Brookhaven National Laboratory
Plant Engineering - E&CS Division
Engineering Change Notice Form

PROJECT: CCWF II **JOB No.** 11705

ECN Title: **Chiller mtr, pump mtrs, and cooling tower fan mtrs nameplate data** **ECN No.**46

Affected Documents: E-601, E-603, E-606

PART OF DWG E-601

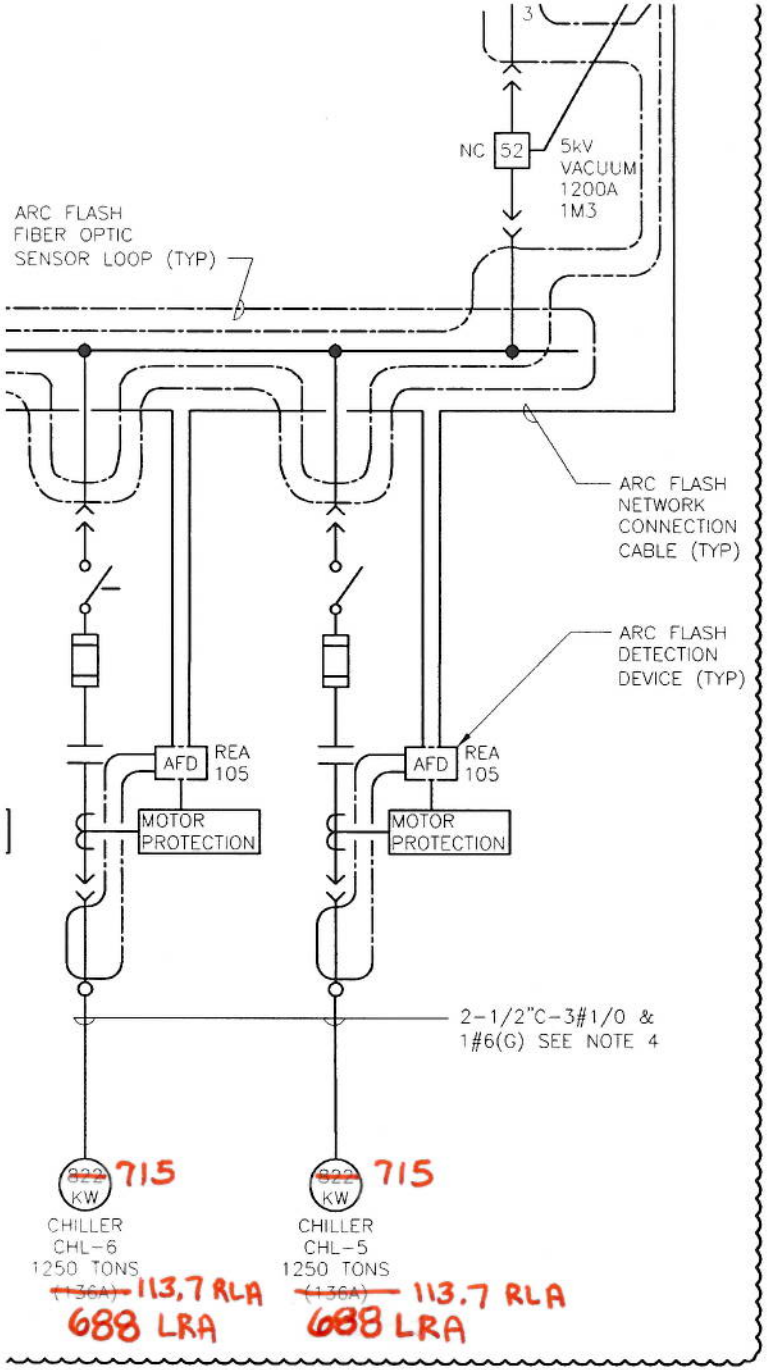
Requested Change (Attach sketch if applicable): Show actual nameplate motor RLA, LRA, & kW for Chiller motors CHL-5 & CHL-6 on drawings. Show actual nameplate motor RLA for PCHP-8, PCHP-9, CHP-5, CHP-6, CWP-5, CWP-6, CTC-5, & CTC-6 on drawings.
